RE: Amendment Application for the Witberg Wind Energy Facility DEA ref. 12/12/20/1966/AM6

This statement letter is in reference to the authorized Witberg Wind Energy Facility (WEF) and the request by Savannah Environmental for comment on the ecological implications of the proposed changes to the layout and turbine specifications that would be included in the Amendment. Witberg Wind Power (Pty) Ltd is proposing to amend the EA as follows:

Figure 1. The ecological sensitivity map of the Witberg site and the 25-turbine layout as provided for the current assessment.

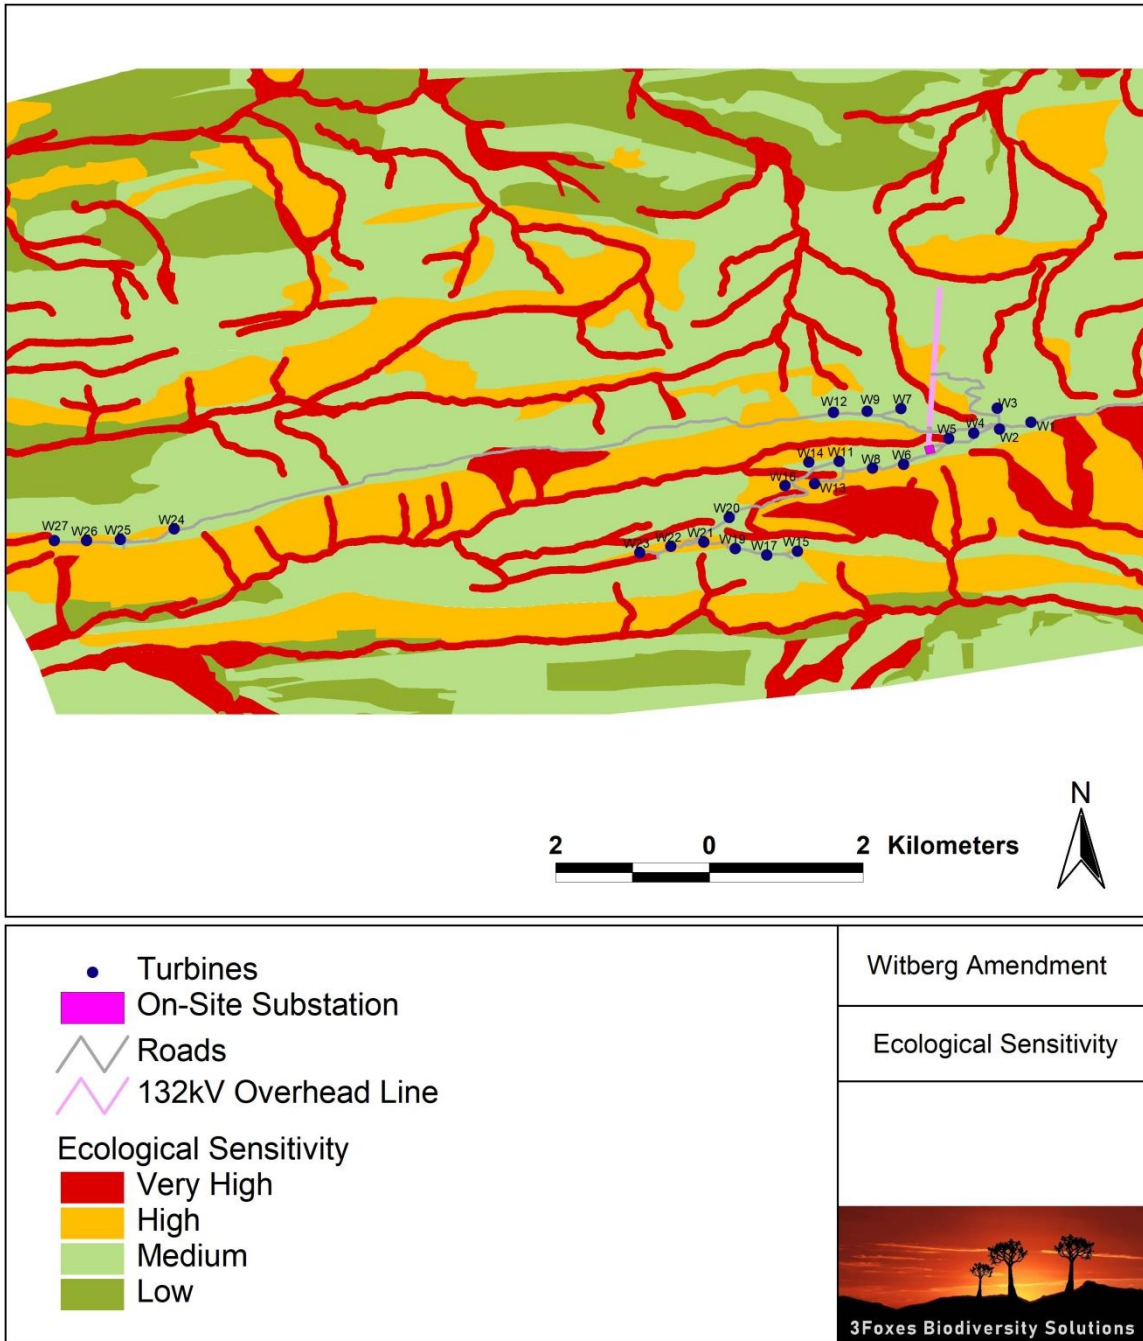
I have reviewed the amended layout in reference to both the previously amended and approved layout as well as the ecological sensitivity of the site. The previous layout consisted of 27 turbines while the current proposed amended layout this has been reduced to 25 turbines. The amendment includes increasing the size and output of the turbines and in terms of impacts on terrestrial ecology, this would not be likely to generate any additional impacts or noticeably increase any previously assessed impacts. The increase in the size of the turbines is offset by the reduction in the number of turbines. As such, **the change in the turbine number and specifications is not considered to have material additional or reduced impact on terrestrial ecology** and as such, no changes to the previously assessed impacts are recommended as a result of the changes to the turbines.

The amendment includes some changes to the layout including the repositioning of some of the turbines. While the majority of turbines are in close proximity to their original positions, with minimal potential change in impact, three turbines have been lost from the east of the site and repositioned on ridges to the west. The revised positions have been interrogated and found to be within acceptable positions where their impact is likely to be similar as the previous positions and no additional impact can be anticipated as a result of the changes. Consequently, there is no change to the assessed impacts as a result of the change in turbine positions. The additional changes to the layout such as access roads, power line, construction camp and substation position, have also been reviewed and no changes to the impact of the development on terrestrial ecological features were found to have occurred. As such, it is concluded that the change to the layout of the development has not had an impact on the previously assessed impacts associated with the development.

Although, no additional impacts are likely to occur as a result of the amendment, it should be noted that the effected environment is considered sensitive and a variety of plant species of high conservation concern are known from the immediate area. As previously noted and reiterated here, the need for a pre-construction walk-through of the entire development footprint with local adjustment to the routing of access roads and micro-siting of turbines where deemed necessary should occur should the development proceed to construction. A pre-construction walk-through of the facility would also be required in order to comply with the permit conditions for the development as a variety of protected species may be impacted and a permit from CapeNature would thus be required.

- The findings of this statement are contingent on the layout as provided for the assessment. There are a variety of sensitive and threatened species at the site which are vulnerable to impact and which can be affected by changes to the development layout.
- Should the development proceed to construction, the final development footprint should be subject to a pre-construction walk-through to inform the final placement of roads and turbines as well as locate and identify species of conservation concern that are within the development footprint. Some search and rescue of plant species of conservation concern may be required.
- The Witberg Amended layout is supported in terms of terrestrial ecology impacts as it will not result in an increase in the significance in any of the assessed ecological impacts and is not considered substantially different from the previous 27 turbine layout.
